Form 3160-5
(June 2019)UNITED STATES
DEPARTMENT OF THE INTERIOR
BUREAU OF LAND MANAGEMENTFORM APPROVED
OMB No. 1004-0137
Expires: October 31, 2021**SUNDRY NOTICES AND REPORTS ON WELLS**
Do not use this form for proposals to drill or to re-enter an abandoned well. Use Form 3160-3 (APD) for such proposals.

8. Well Name and No. HAWK 35 FED/207H

Hawk 35 Fed 101H (FKA 207H) API #: 30-025-47897

EOG respectfully requests an amendment to our approved APD for this well to reflect the following changes:

WELL LOCATION AND ACREAGE DEDICATION PLAT

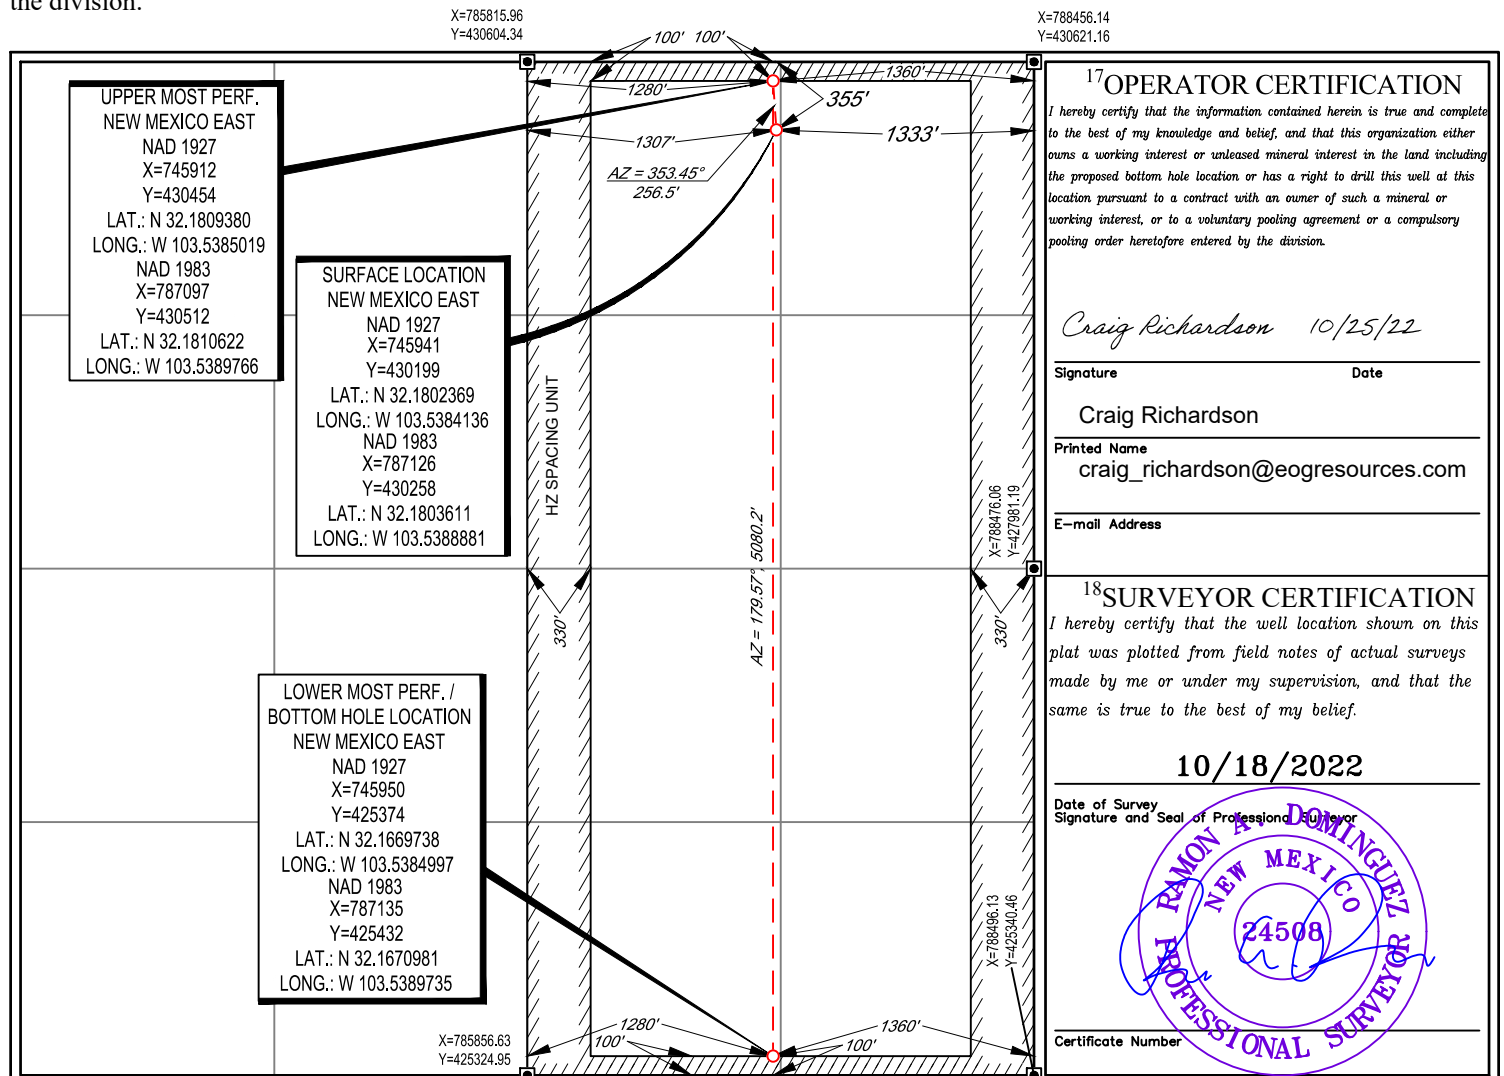
Change SHL from T-24-S, R-33-E, Sec 35, 624' FSL, 936' FEL, Lea Co., NM,
to T-24-S, R-33-E, Sec 35, 355' FNL, 1333' FEL, Lea Co., N.M.Change BHL from T-24-S, R-33-E, Sec 35, 100' FNL, 1700' FEL, Lea Co., NM,
to T-24-S, R-33-E, Sec 35, 100' FSL, 1360' FEL, Lea Co., N.M.

UL or lot no.	Section	Township	Range	Lot Idn	Feet from the	North/South line	Feet from the	East/West line	County
B	35	24-S	33-E	-	355'	NORTH	1333'	EAST	LEA

UL or lot no.	Section	Township	Range	Lot Idn	Feet from the	North/South line	Feet from the	East/West line	County
0	35	24-S	33-E	-	100'	SOUTH	1360'	EAST	LEA

Revised Wellbore A:

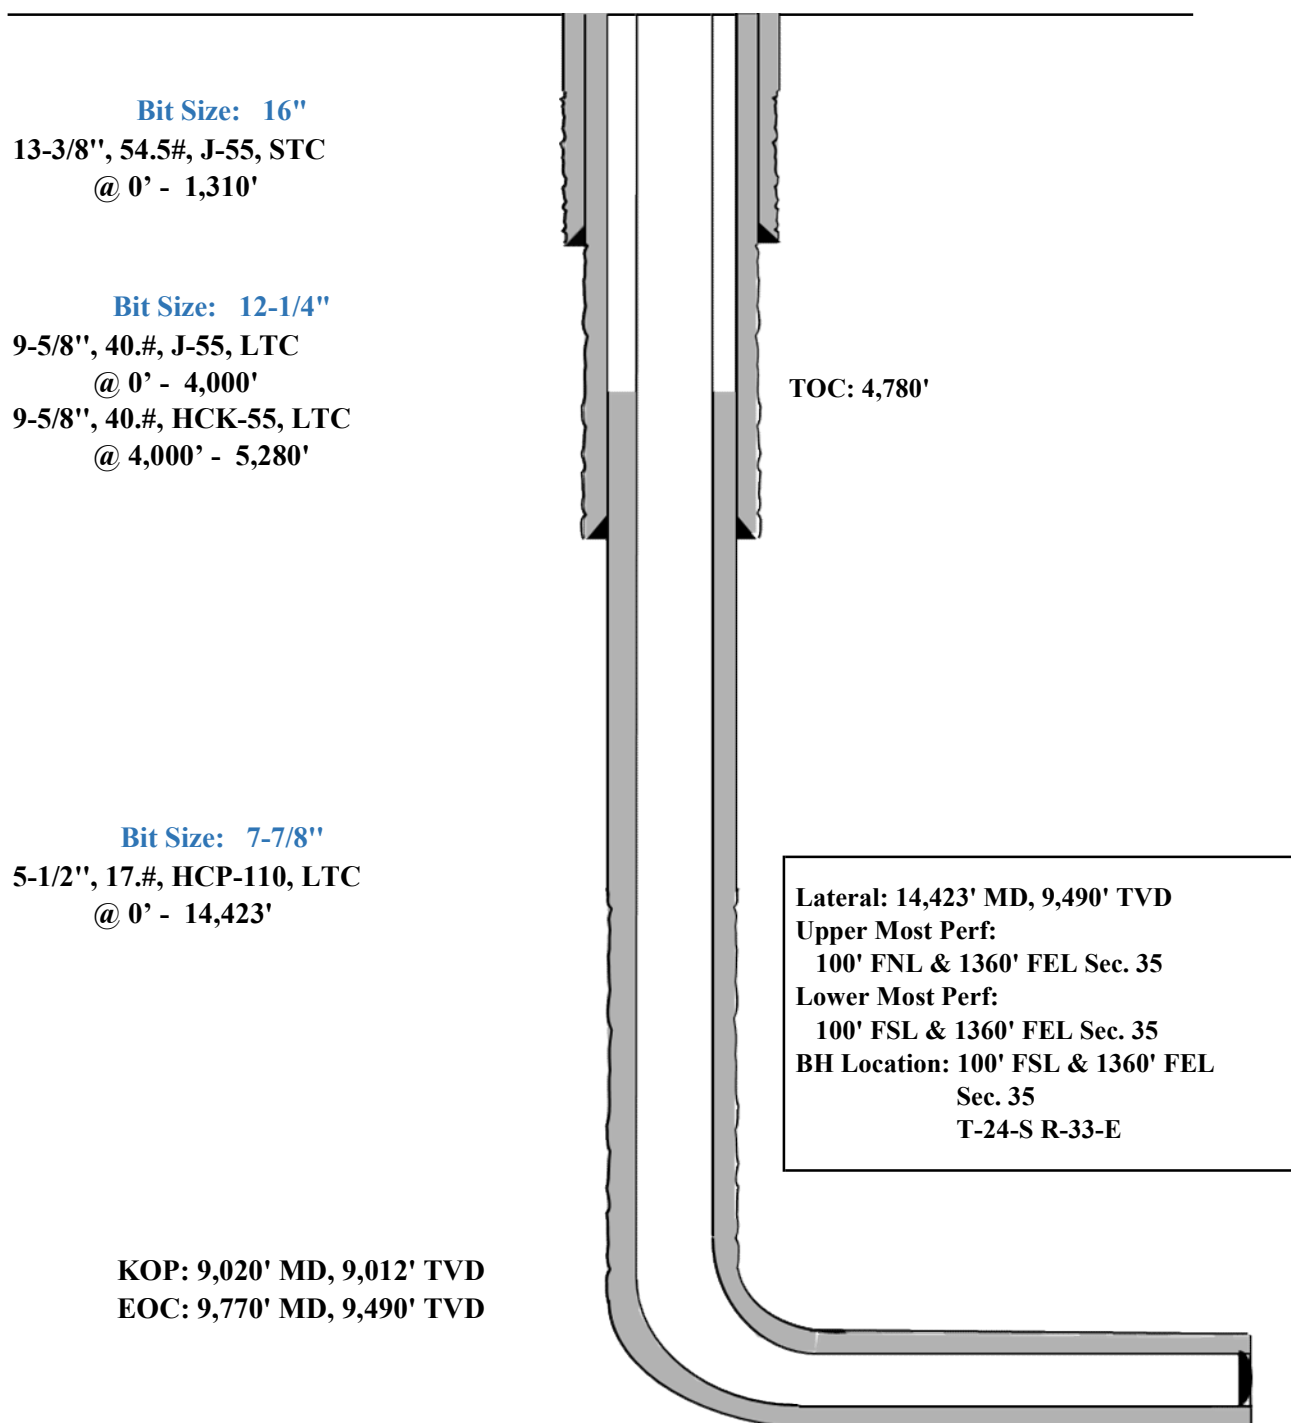
Update casing and cement program to current design.

Variance is requested to waive the centralizer requirements for the 9-5/8" casing in the 12-1/4" hole size. An expansion additive will be utilized, in the cement slurry, for the entire length of the 12-1/4" hole interval to maximize cement bond and zonal isolation.

Variance is also requested to waive any centralizer requirements for the 5-1/2" casing in the 7-7/8" hole size. An expansion additive will be utilized, in the cement slurry, for the entire length of the 7-7/8" hole interval to maximize cement bond and zonal isolation.
